## Unanswered Questions part 2

After Deadline 9 there were still at least 10 unanswered questions so as soon as the main Interested parties had had their submissions posted I thought I would see whether any have been answered.

10 questions still unanswered

*v. The figure below shows the original Site 1 centre point as explained in response to part iv above. The revised Site 1, the location being considered by Aquila, remains outside the Order Limits and outside the Manston Green site.*

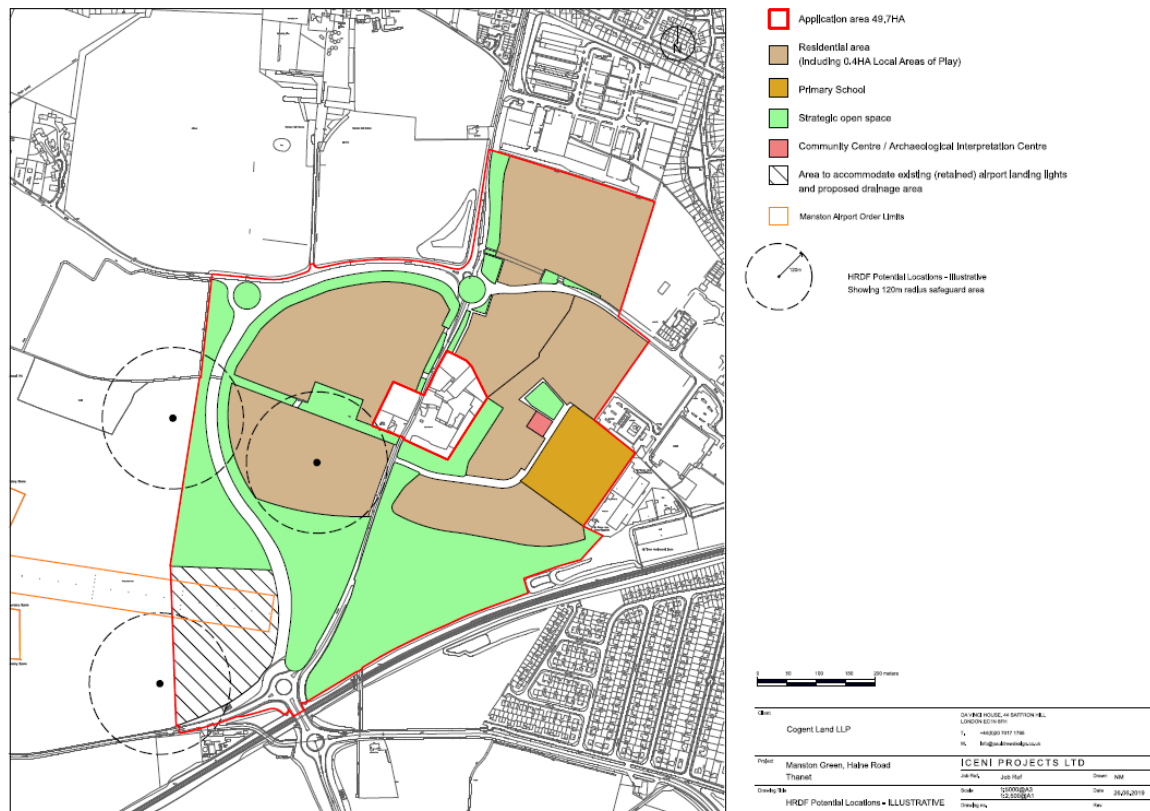
“Cogent were not made aware of the need to relocate the HRDF, nor the alternative locations proposed, despite two of these locations to the east of the Airport in close proximity to Manston Green and likely to impact upon the development. In fact, it was fortunate that Cogent had a representative present at the Hearing Session on 4th June 2019 when the MoD raised concerns of the potential impacts of the HRDF relocation, as the Applicant had not consulted with Cogent.”

“We understand that, at no point during the discussions, were the MoD made aware of the existing planning permission associated with Manston Green, and as such also expressed concerns that the Applicant was unable to provide written evidence from the landowners confirming that the relocation of the HRDF on their land would be acceptable, (despite the Applicant claiming that discussions with the relevant parties had taken place (although we are aware this was not the case)).”

Both the DIO and Cogent have yet to have the situation anywhere near resolved which is in complete contrast to the statements made by Riveroak in their submission.

*“Site 1 was identified as a potentially suitable as a location for the HRDF. Following subsequent technical assessment of this area, a revised location 250m to the north west of this point was proposed by Aquila; this was accepted by RSP. These are not the only locations being considered as a possible location for the HRDF. A number of potential sites are being considered by Aquila, including*
